## Work Order ID 101523.

Item Name: Crosstube Turning Detail

<b>DART AEROSPACE LTD</b>	<b>Work Order:</b>	<b>101523</b>
<b>Description:</b> Crosstube Assembly (412 High Aft)	<b>Part Number:</b>	<b>D412-664-243</b>
<b>Inspection Dwg:</b> D412-664-243 <b>Rev:</b> E		<b>Page 1 of 2</b>

DRAWING NO. D412-664-243	TITLE CROSSTUBE ASSEMBLY (412 HI AFT)	REV. E	DART AEROSPACE LTD ENGINEERING ORDER		D.E.O. NO. D412-664-243-E-4	SHEET NO. SHEET 1 OF 3	SCALE NTS
DRAWN 90	CHECKED A	MFG. APPR. A	APPROVED MP		DE APPR. MP		
DATE 12.08.21	DATE 12.08.30	DATE 12.08.30	DATE 12/8/30		DATE 12.08-30

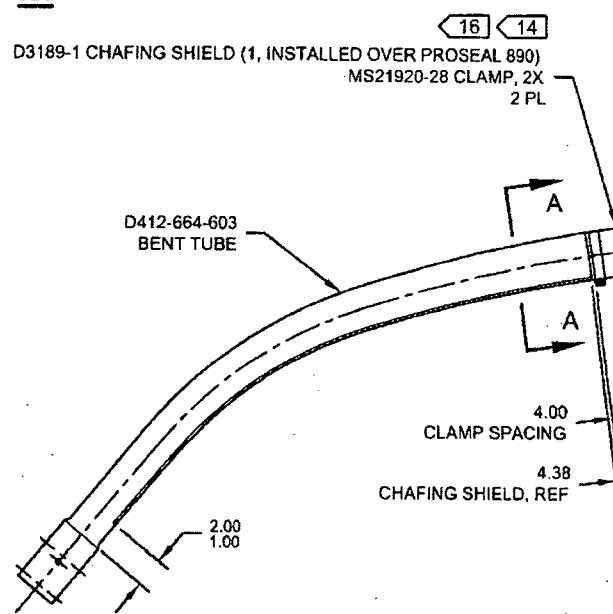
REMOVED ABRASION STRIP IN FAVOR OF A THIN LAYER OF PROSEAL 890. UPDATE INSTALLATION OF CHAFING SHIELDS AND REDUCE TORQUE TO 40-50 IN-LBS. THIS ENGINEERING ORDER SUPERCEDES DEO D412-664-243-E-1.

NOTES 2, 14, AND 16 ON SHEET 1 ARE AMENDED AS FOLLOWS:

- 2) FINISH: CHEMICAL CONVERSION COAT PER DART QSI 005 4.1  
PRIME INSIDE AND OUTSIDE PER DART QSI 005 4.2  
PAINT OUTSIDE PER DART QSI 005 4.2
- 14) INSTALL D2856-600-1009 ABRASION STRIPS WITH A 0.13 REF GAP ON BOTTOM SIDE OF CROSSTUBE PER QSI 035.
- 16) TORQUE CLAMPS 80 TO 100 IN-LB. ENSURE AT LEAST 1.5 THREADS SHOWING IN SAFETY AND THAT NUT HAS NOT BOTTOMED-OUT AFTER TORQUING.

- 2) FINISH: CHEMICAL CONVERSION COAT PER DART QSI 005 4.1  
PRIME INSIDE AND OUTSIDE PER DART QSI 005 4.2  
MASK UNDERSIDE OF CROSSTUBE AS SHOWN (HATCHED AREA)  
PAINT OUTSIDE PER DART QSI 005 4.2  
AFTER PAINTING, APPLY CLEAR COAT ON HATCHED AREA
- 14) APPLY A THIN COAT OF PROSEAL 890 ON INSIDE CONCAVE SURFACE OF D3189-1 CHAFING SHIELD AND LET CURE PER MANUFACTURER'S INSTRUCTIONS. INSTALL PROSEALED D3189-1 CHAFING SHIELD ONTO CROSSTUBE BY APPLYING A THIN COAT OF PROSEAL 890 ONTO CROSSTUBE. BE SURE TO ELIMINATE ANY AIR GAPS.
- 16) TORQUE CLAMPS ON D2896-1 SUPPORT 80 TO 100 IN-LB. **TORQUE CLAMPS ON D3189-1 CHAFING SHIELD 40 TO 50 IN-LB.** ENSURE AT LEAST 1.5 THREADS SHOWING IN SAFETY AND THAT NUT HAS NOT BOTTOMED-OUT AFTER TORQUING.
